Product Update: CR-V Throttle Cable

CORRECTIVE ACTION

Install a cap on the throttle drum.

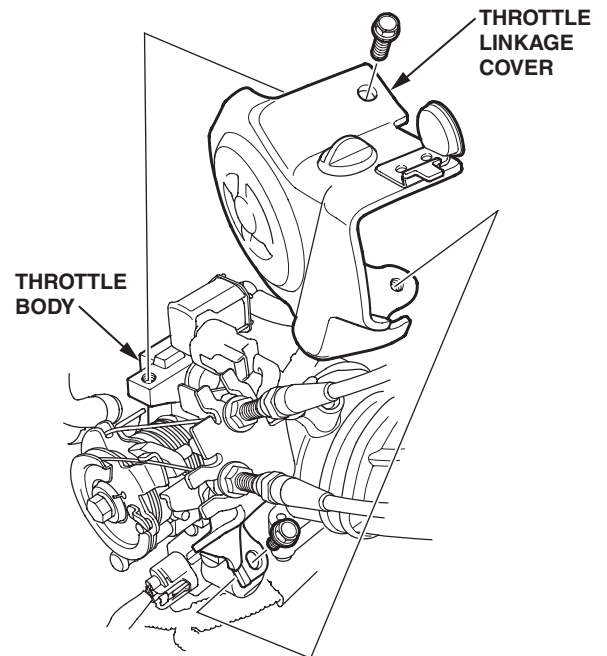
Throttle Drum Cap: P/N 16403-PPA-003

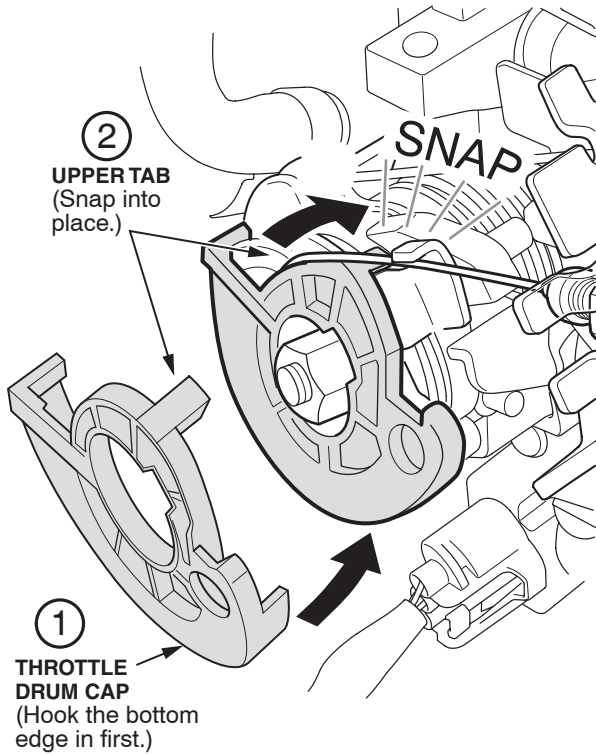
1. Remove the throttle linkage cover from the throttle body.

2. Install the throttle drum cap on the throttle drum by pressing its lower half onto the drum and then snapping its upper tab into place.

3. Rotate the throttle drum, and make sure the cap is completely seated.
4. If there is a gap between the cap and the throttle drum, remove and discard the cap, then repeat steps 2 and 3 with a new cap.
5. Install the throttle linkage cover, and torque the bolts to 12 N·m (8.7 lb-ft).
6. Center-punch a completion mark above the fifth character of the engine compartment VIN.
